MIDLAND PLANT UNITS 1 AND 2
RESPONSE TO NRC STAFF REVIEW CONCERNS
FOR UNDERPINNING OF THE AUXILIARY BUILDING

JUNE 3, 1982

Midland Plant Units 1 and 2
Response to NRC Review Concerns
for Auxiliary Building Underpinning

Figure 2-15
PARAMETRIC STUDY I

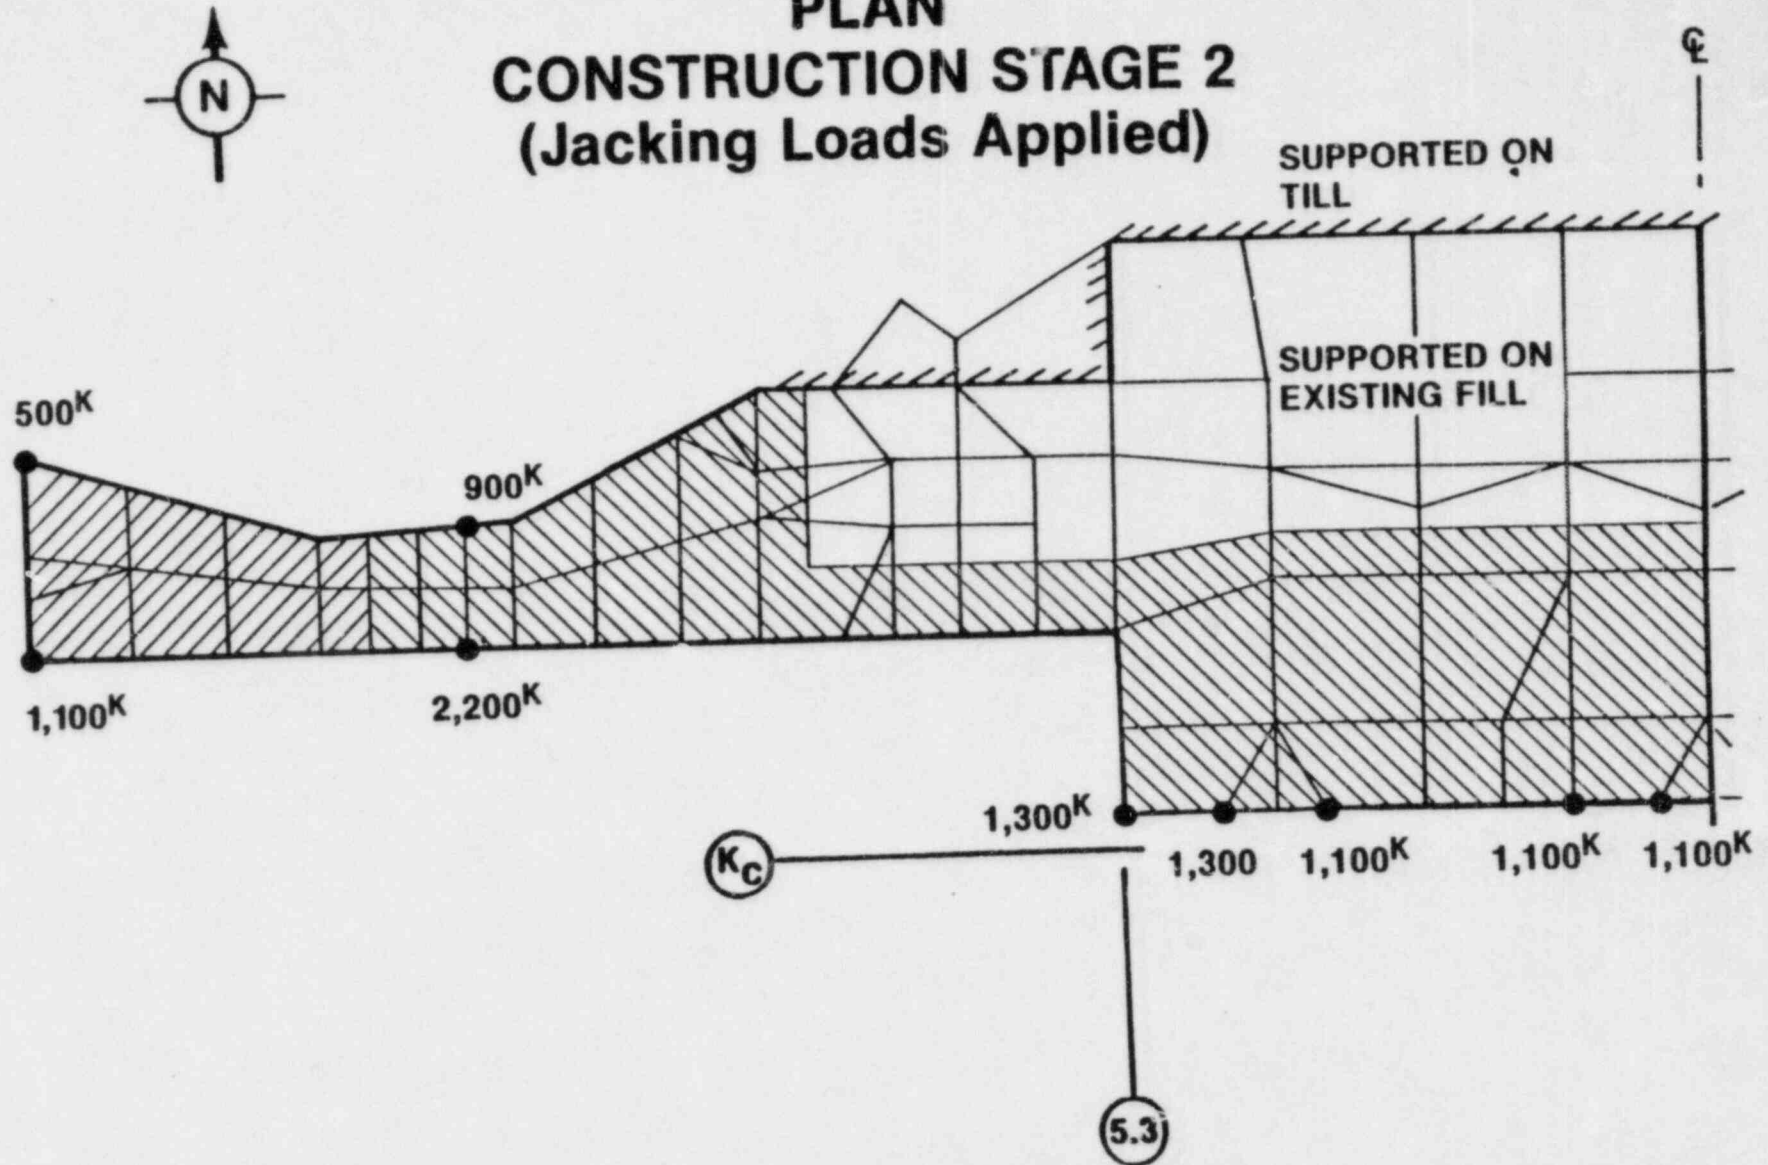
At the end of excavation in Stage 2, the design jacking loads will be applied to the structure as shown in Figure 2-15.

Figure 2-16
PARAMETRIC STUDY I

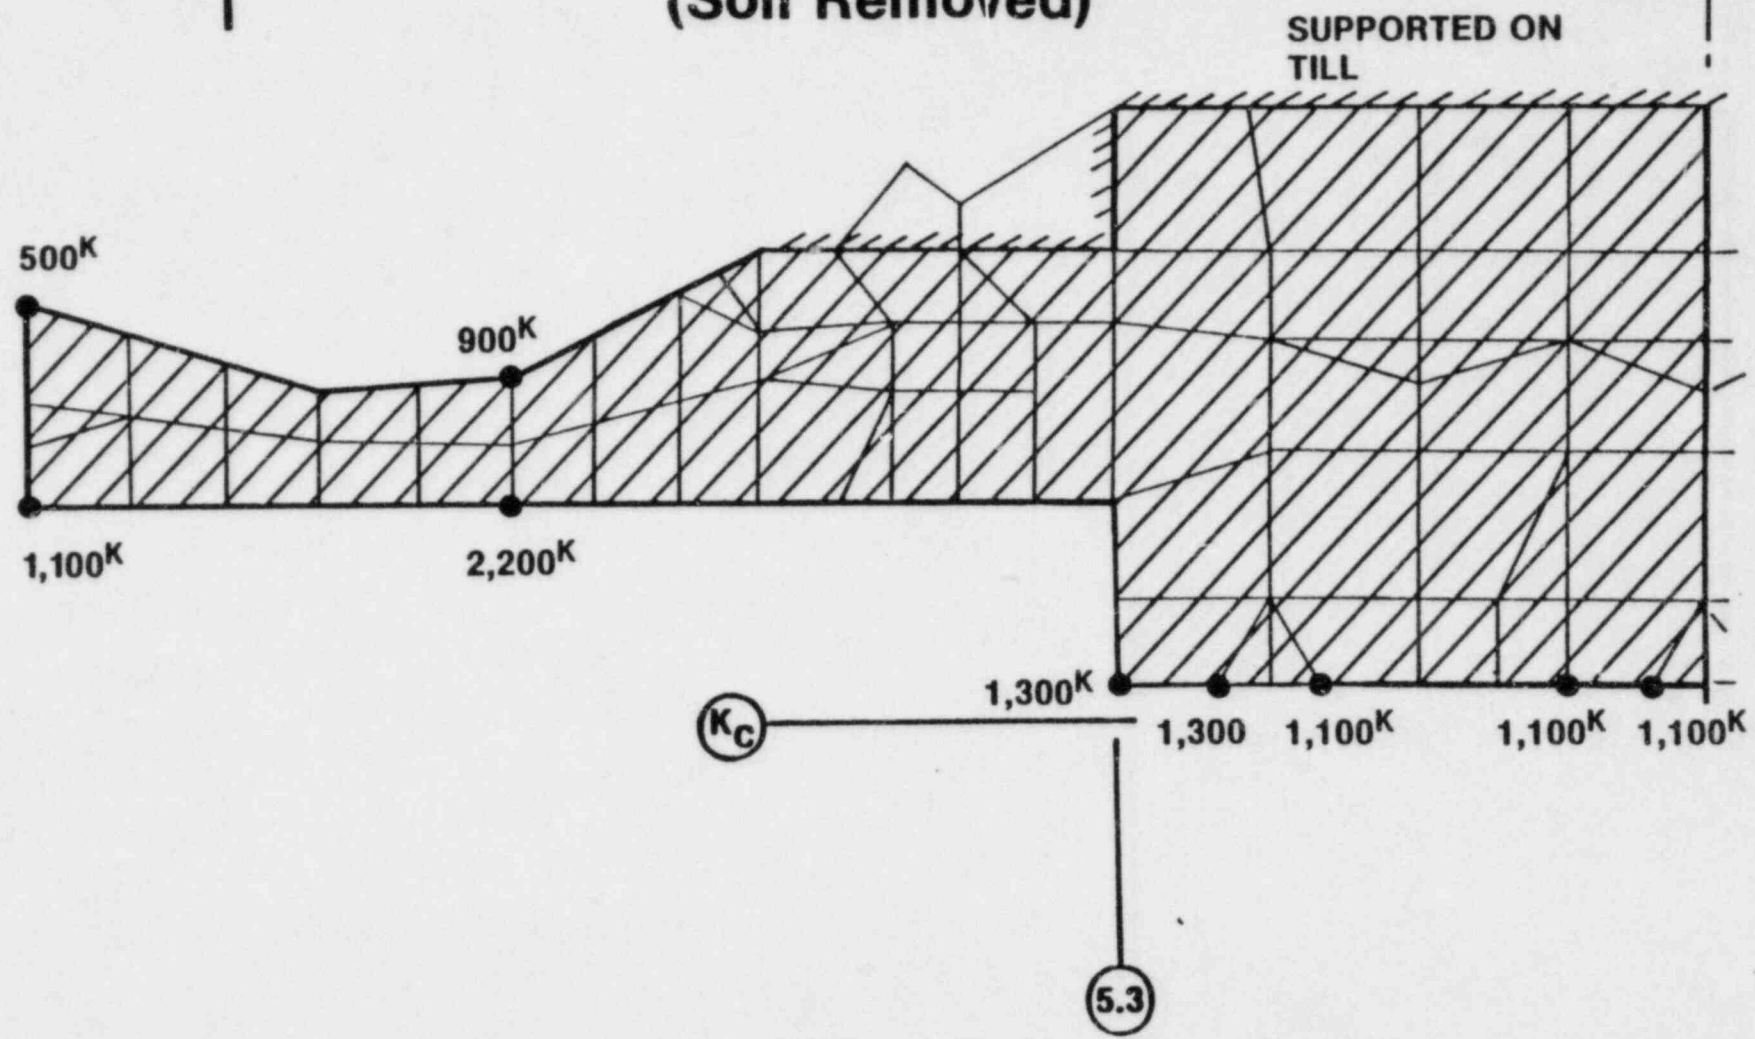
- a. The jacking loads (shown in parentheses in Figure 2-16) at the ends of the EPA and piers CT1 and

PARAMETRIC STUDY 2
Figure 2-18

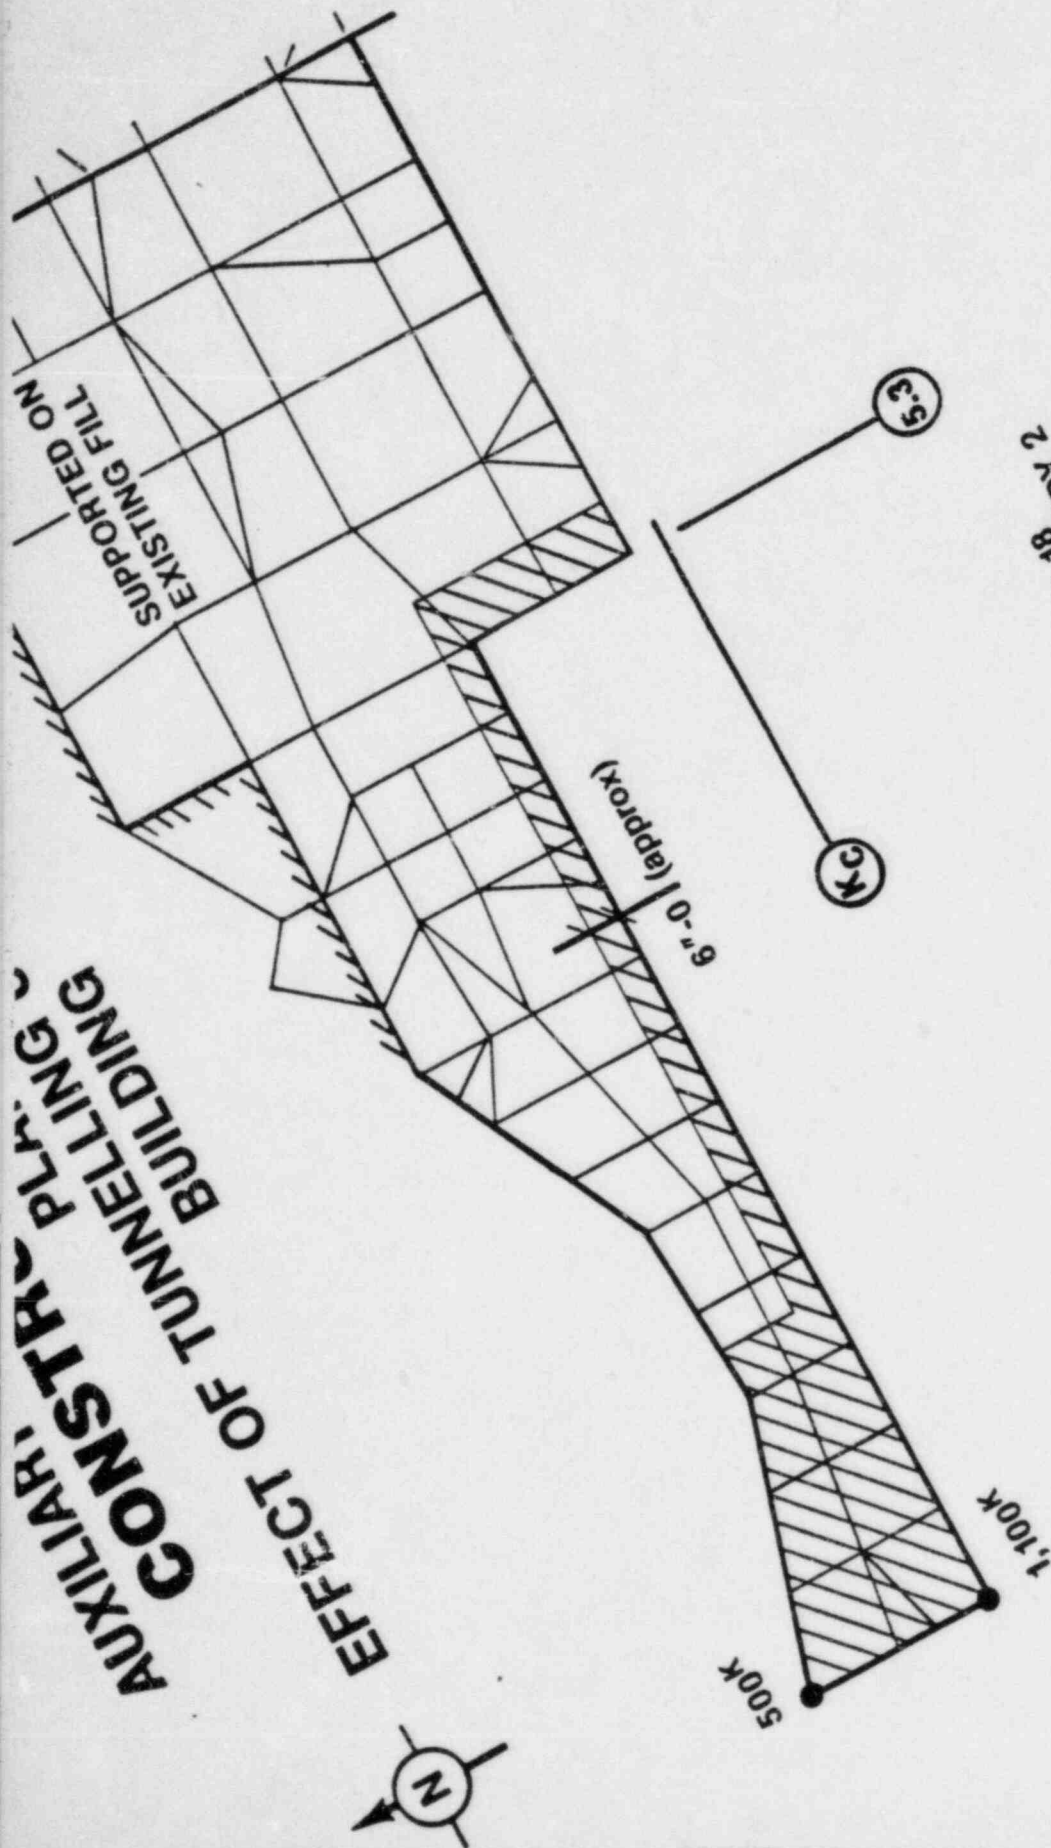
This study has been performed to analyze the effect of tunneling under the turbine building after the ends of the EPA have been supported by jacks, as shown in Figure 2-18. It has been assumed that, because of tunneling under the turbine building, a strip approximately 6 feet wide on the south side of the EPA will lose soil support.

Figure 2-19

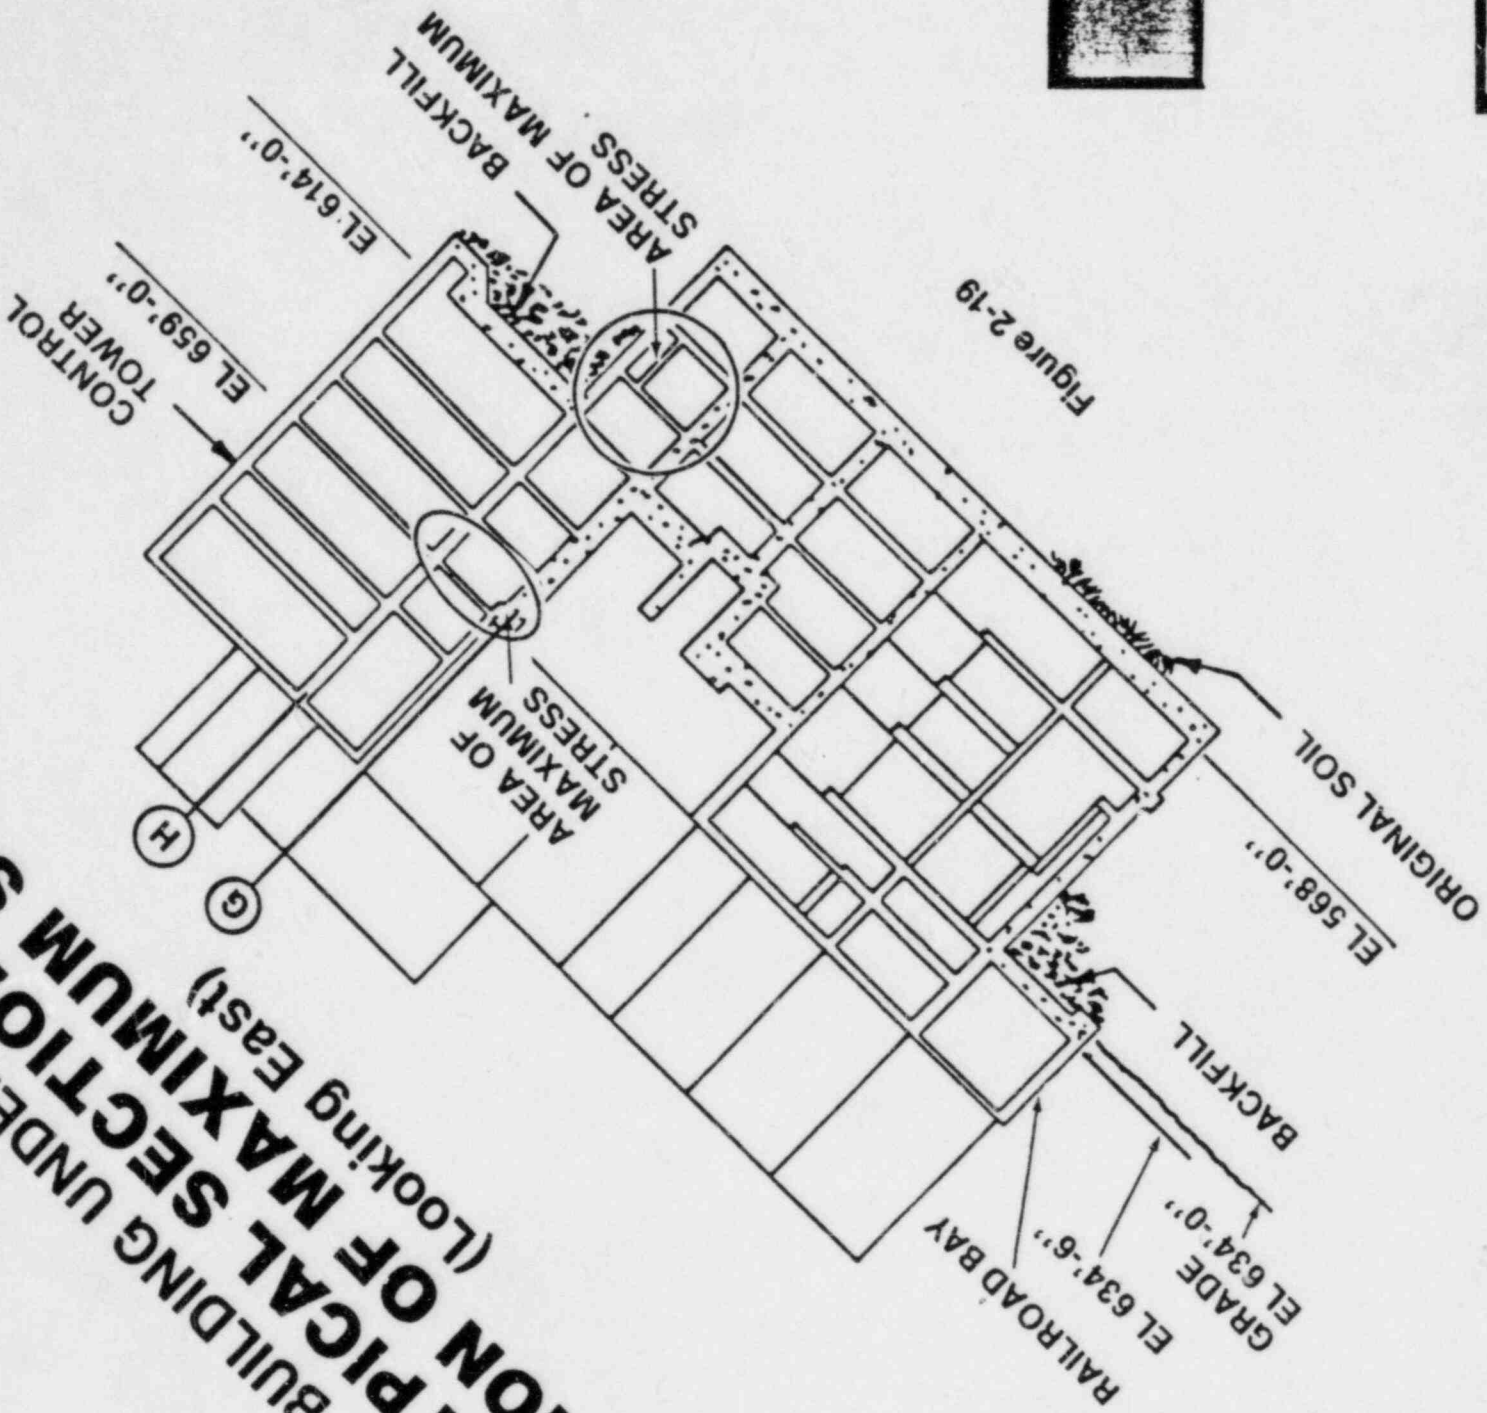
The areas of maximum stress have been identified in Figure 2-19, and Table 2-4 shows the average stress in the rebar during the various construction stages. As Table 2-4 indicates, despite the conservative assumptions, there is no overstressing of the structure.
